MEMORANDUM

Re: Modifications to Planned Development and Design Review Approvals for The Harvey (PLNPCM2021-01092 and PLNPCM2021-01254)

REQUEST: The Harvey previously received Planned Development and Design Review approvals from the Planning Commission on February 9, 2022. The applicant has requested modifications to the approved design. These changes are required by ordinance to be reviewed by the Planning Commission as only minor modifications can be approved administratively.

Construction costs increased following the submittal of the plans for review. The applicant is requesting changes to address these increased costs, primarily by removing concrete and steel elements. See the applicant's submittal for additional information. These revisions are beyond what is permitted for an administrative minor modification review from what was previously approved by the Planning Commission. The approval process for modifications to approved plans is described in the Zoning Ordinance:

Approved Plans: North Elevation – The applicant requested additional building height from grade to the top of the parapet is 26’. The materials included brick, board form concrete, and brick cladding on the trash enclosure.

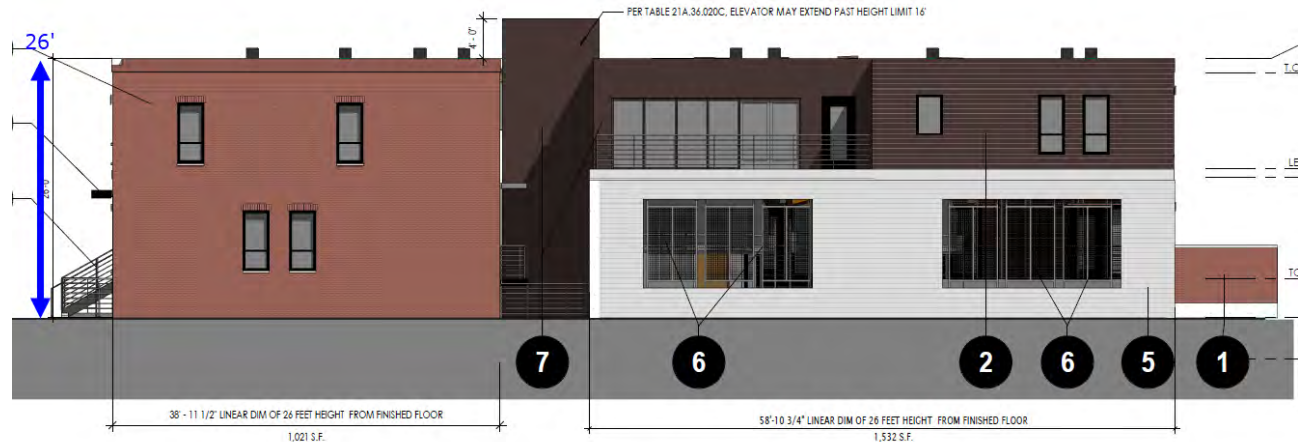
Proposed Plans: North Elevation – Several material changes are proposed on this elevation:

- Change some of the garage from formed concrete to frame construction and clad with fiber cement siding. The formed concrete was not necessary. The remaining concrete is smooth rather than board formed.
- Change the garage doors from a solid door to steel mesh retracting doors. These will allow for improved air flow and help meet building code requirements, while still providing security to the parking.

- Change the materials in the lightwell area that is visible from the alley right-of-way from fiber cement siding to stucco.
- Change the material of the trash enclosure from brick to color matching CMU brick.

The additional building height (26') requested with the Planned Development is not changing.

Approved Plans: East Elevation – The average building height from grade to the top of the parapet is 26'. The materials included brick, fiber cement siding, and board formed concrete.

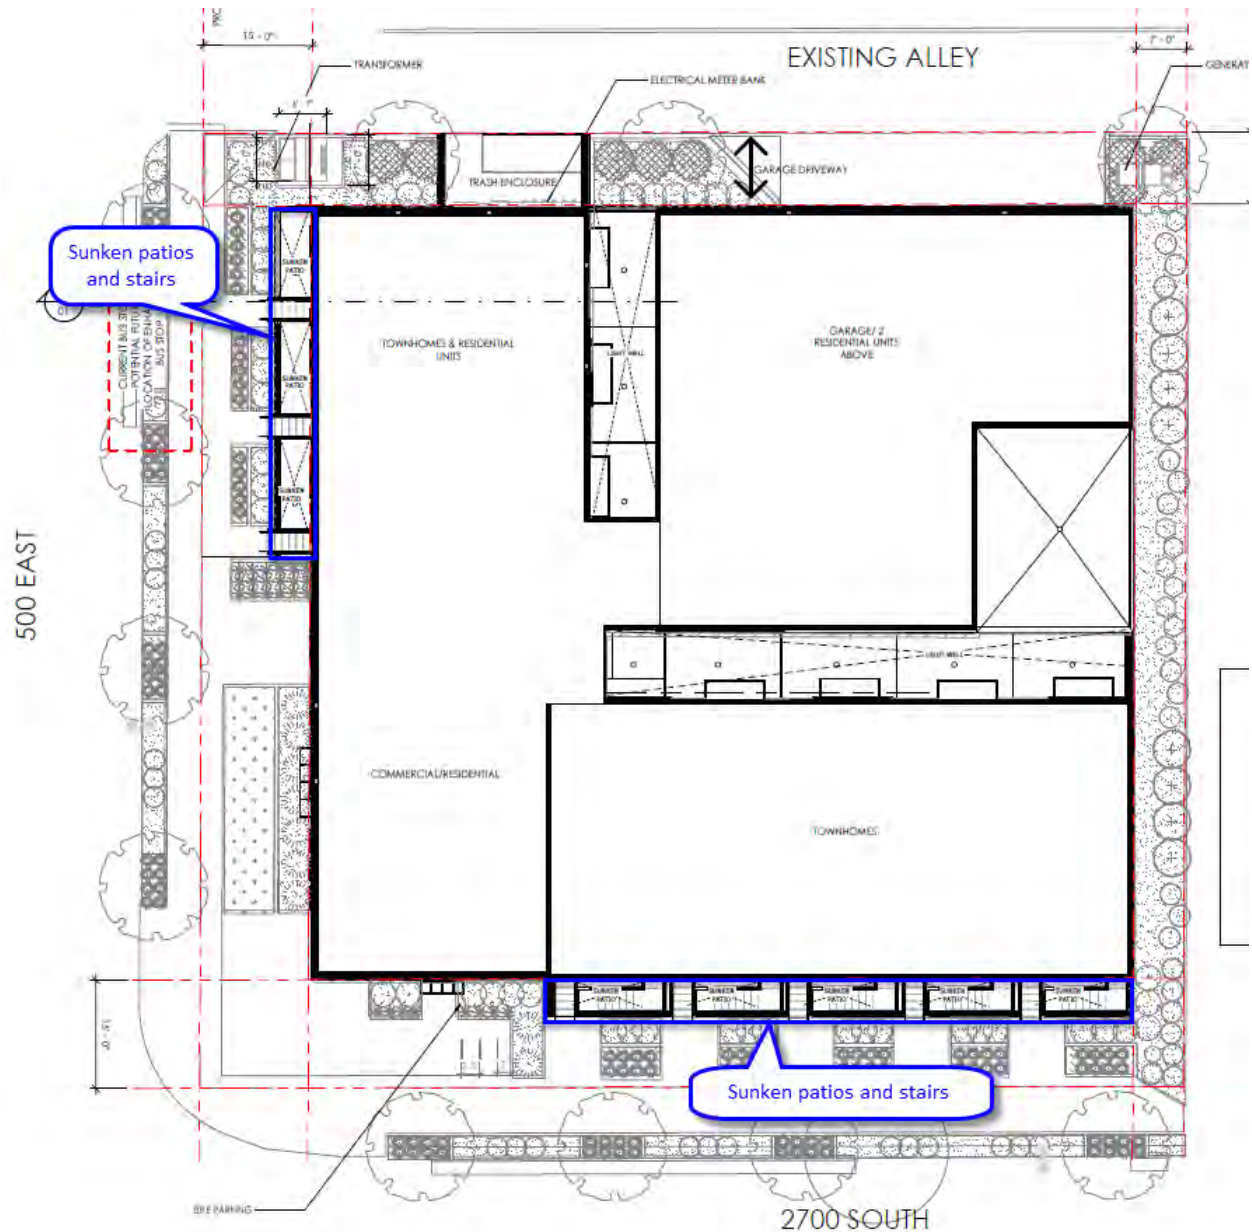
Proposed Plans: East Elevation – The applicant proposes material changes on this elevation as follows:

- Change the lightwell and the northern portion of the second floor from brick to stucco. Brick on the north wraps around on the east.
- Change some of the exterior of the garage from board formed concrete to fiber cement siding. The remaining concrete is smooth rather than board formed.

Approved Site Plan – Sunken patios and stairs on 500 East and 2700 South frontages. The patios encroach into the required front and corner side yard setbacks and were part of the Design Review request.

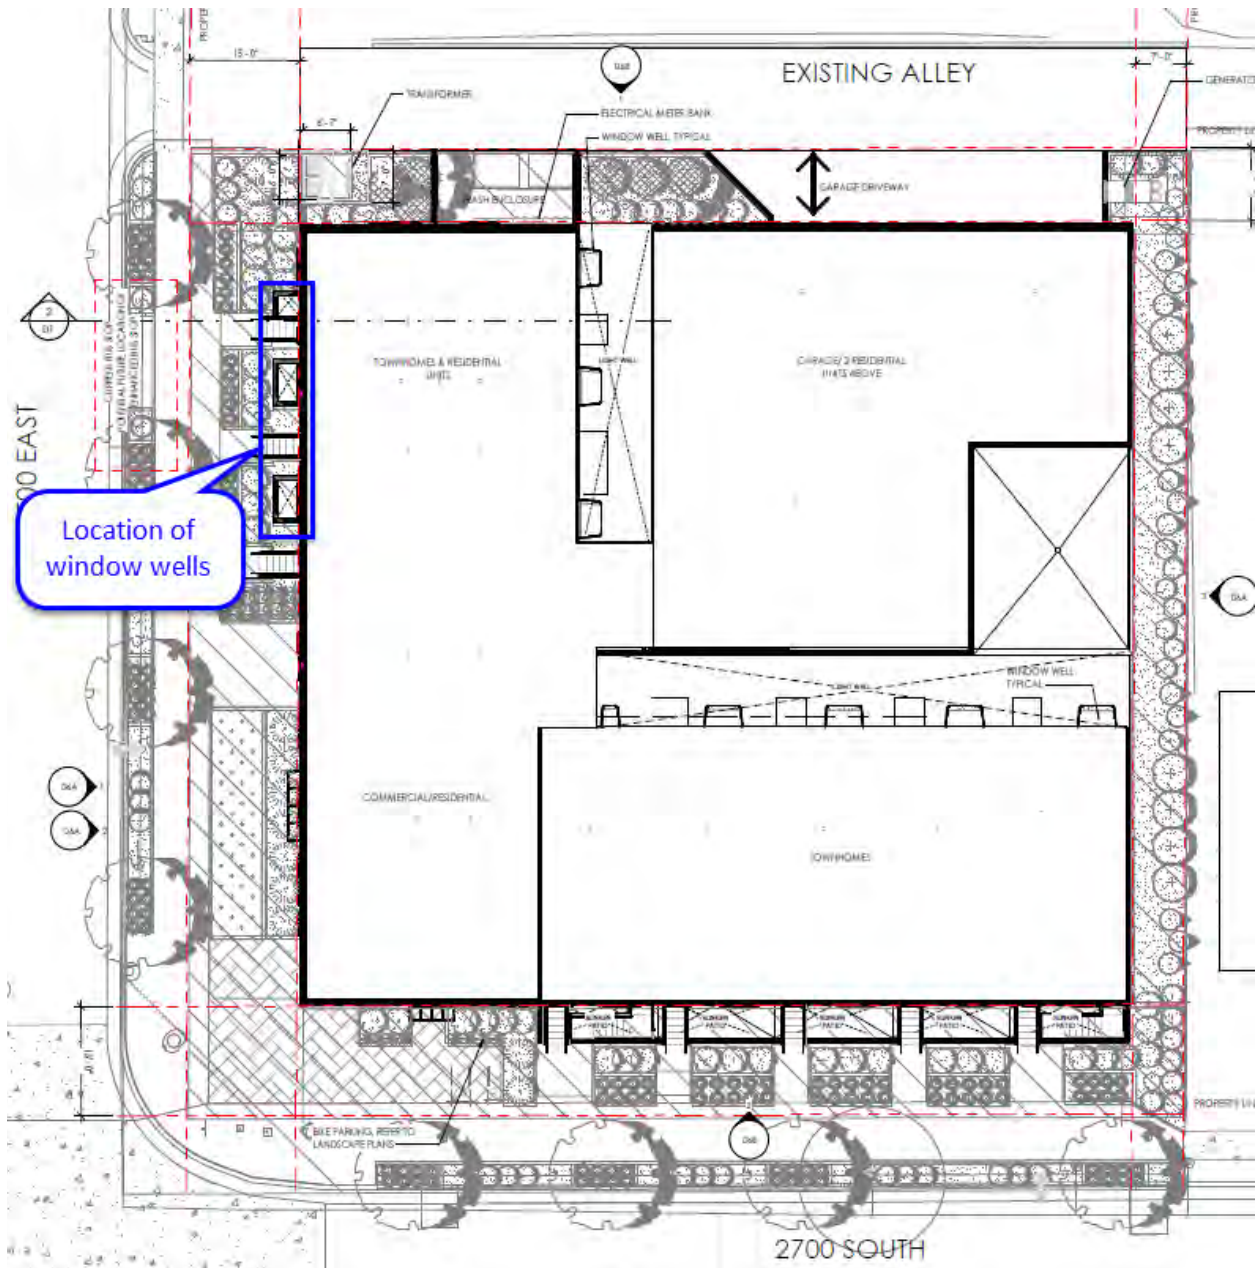
The applicant requested Design Review approval for the sunken garden level patios to extend into the front/corner side yard setbacks on 500 East and 2700 South. The modification of the patios to window wells on the 500 East/west façade removes the need for the reduction in the required setback on this façade. With the proposed modification, the proposal meets the requirements of the base zoning district on 500 East/west façade. The request is still required for the 2700 South/south façade.

Proposed Plans – Sunken patios removed on the 500 East frontage and replaced with window wells. The relief from the required front/corner side yard setback was part of the Design Review request. The proposal is more conforming with the CN zoning district.

Partial Site Plan – The Planned Development requests for the utility transformer, trash enclosure, driveway, and generator are highlighted in blue. As a condition of approval, the transformer shall be fully located in the rear yard.

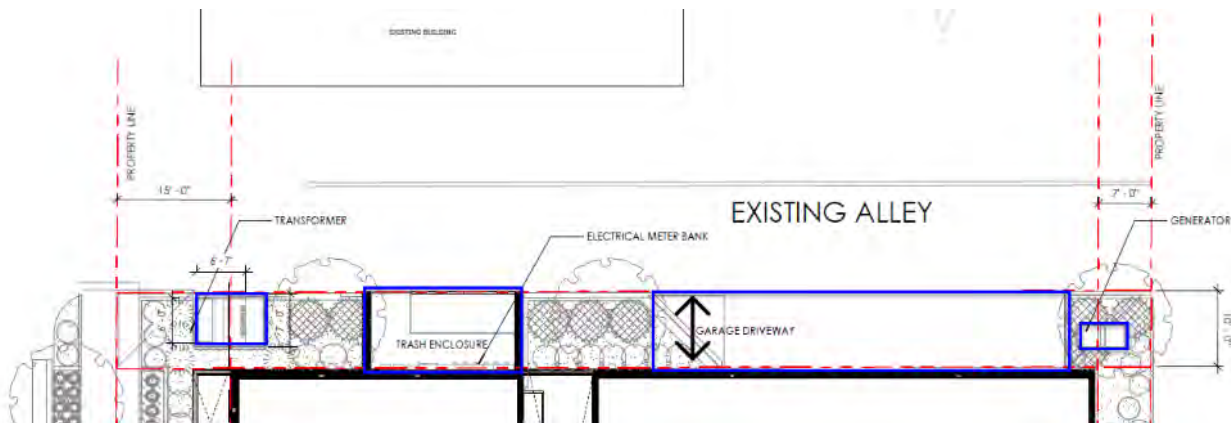
- 1) **Buffer yard and rear yard obstructions** – The utility transformer, trash enclosure, generator and driveway are located to the north of the proposed building. The CN zoning district requires a 7' buffer yard when abutting a residential district. It also requires a 10' rear yard setback. The applicant is requesting a modification to allow for the utility transformer, trash enclosure, generator, and driveway in the buffer yard. Additionally, the applicant is requesting that the utility transformer is in the required rear yard. Recent revisions to the plans placed the transformer partially in the corner side yard. Staff recommends a condition of approval to place this transformer fully in the rear yard.

The utility transformer is 6' x 6'7" and is approximately 4'6" tall. It will be screened by tall grasses. The original requested modification is for it to be in the buffer yard and the rear yard. The preference is for it to be located within the buildable area. Staff supports this request as it remains on the subject property and is screened. However, the most recent plans show it extending into the corner side yard. Staff does not support this modification, but supports a location in the rear yard, which is identified in Condition of Approval #6.

West Elevation – Additional building height requested with the Planned Development for the sunken garden level patios. The average building height from grade on this elevation is 28.5'.

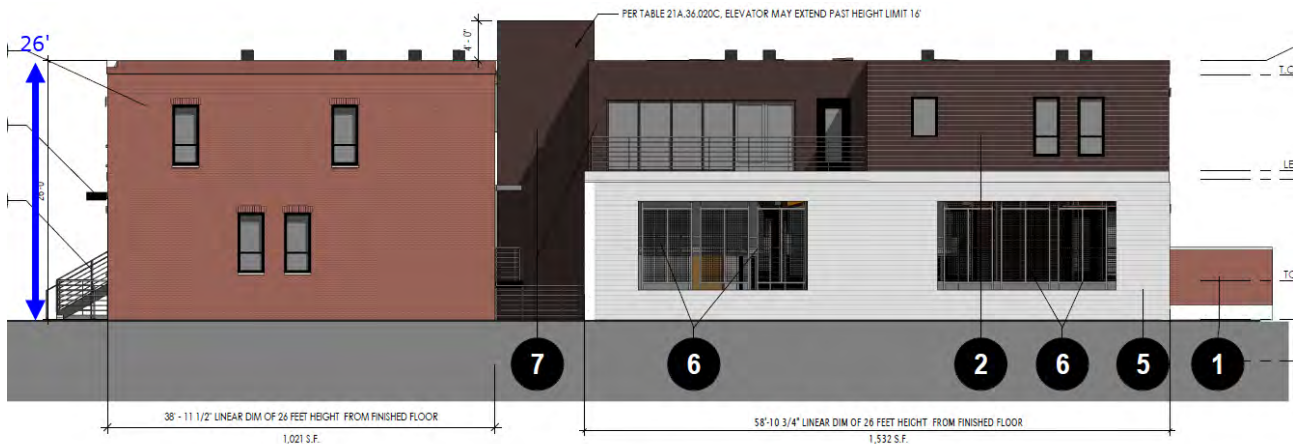
The heights identified by the applicant include 1'6" for the parapet, which is generally not included in the maximum height since the height is measured to the coping on a flat roof. Additionally, 21A.36.020.C allows for a 5' mechanical equipment parapet wall. Excluding the parapet, for the majority of the building, the building height from street level to the top of the coping meets the CN height requirement of 25'. The primary need for the additional height is due to the sunken garden level patios and the definition that requires height to be measured from average elevation at finished grade to the highest point of the coping.

South Elevation – Additional building height requested with the Planned Development for the sunken garden level patios. The average building height from grade on this elevation is 29.8'
